Product Bulletin

Bulletin No.: 032723
Date: March 27, 2023
Subject: New High Recovery Flow Restrictor for the 385 ROs

New: Capillary Style High Recovery Restrictor
P/N 7395634

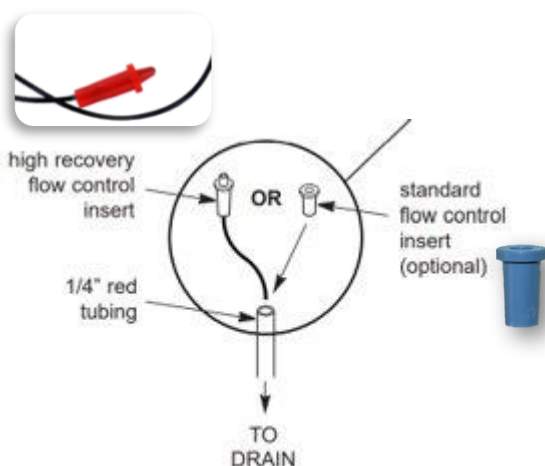
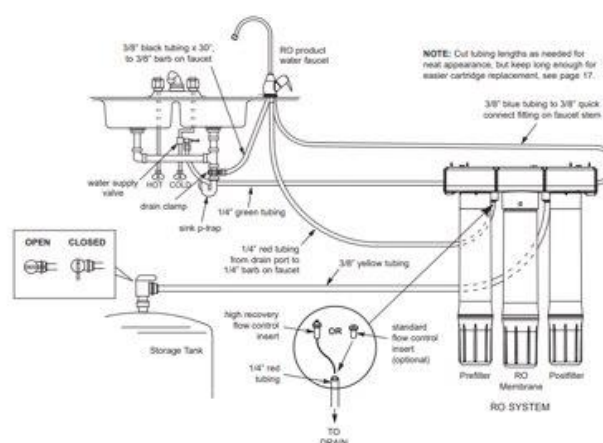
Introduced at the Dealer Convention, the **New High Recovery Flow Restrictor** is now in production. This new restrictor uses a capillary tube design to provide back pressure through the length of the tube. The primary benefits include:

We are no longer using the “inline” style restrictor. The new red capillary restrictor will replace the standard recovery blue version in the same drain line location when high recovery is desired. Both the standard recovery blue and high recovery red capillary restrictors will ship with each model 385 RO.
